LETTER OF SUBMITTAL
KFM Skyway Project # 04-012024

Subject: USI - KFM NCR #30R1 (USI NCR 04-27 Rev. 1) Response to CTL - 4441

Subject: Response to Caltrans State Letter # 5.03.01-004441
KFM NCR #30r1

*Subject: Response to KFM-SUB-002146R02: USI KFM NCR #30R1 (USI NCR 04-27 Rev.1)
Response to CTL 4441*

pb203

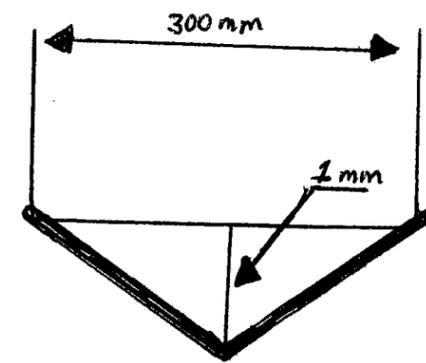
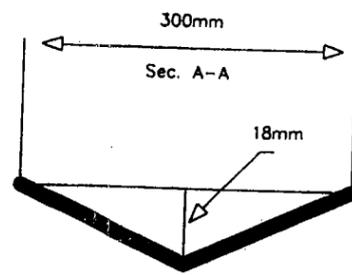
Step 1 - Details of Non-conformance:
Pb203 tendon stiffener, weld splice at transition weld is 18mm out of flat.

Responsible Department: _____ Department Supervisor: _____
Step 2 - Corrective Action: Engineer approval required: yes no
Use heat & limited pressure & limited heat to straighten.
